PURCHASING STANDARD CLAUSE

Clause Number 76-146-4

MODIFICATIONS TO MIL-STD-271

Figure 17A - Accepted scanning techniques for tee welds.

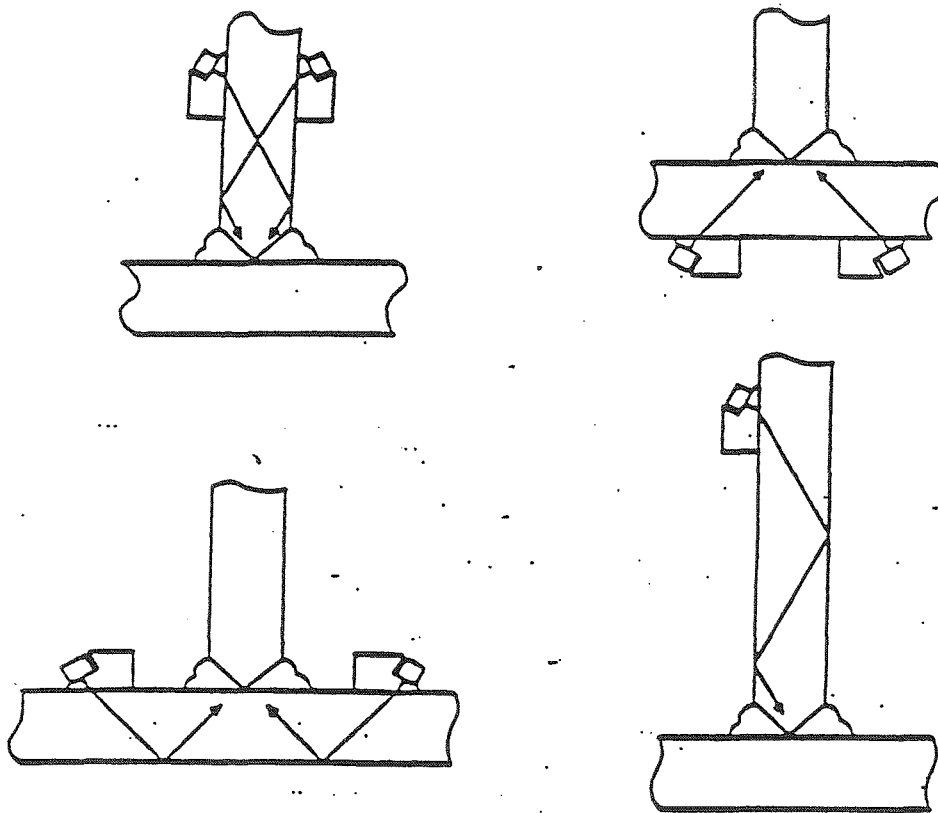
- Page 54, Add paragraph 6.5.4.4.3:

6.5.4.4.3 Volumetric inspection of full penetration tee welds. Inspection shall be performed in accordance with 6.5.4.3., unless otherwise specified below. The weld reinforcement shall be otherwise specified below. The weld reinforcement shall be considered part of the inspection zone. Scanning shall be as required to ensure completed coverage of the inspection zone (see Figure 17A). When accessible, scanning shall be performed from the through member in accordance with 6.5.4.4.1 for the detection of lack of penetration. Cases of inaccessibility shall be approved by the examiner on a case basis.

- Insert the attached Figure as Figure 17A.
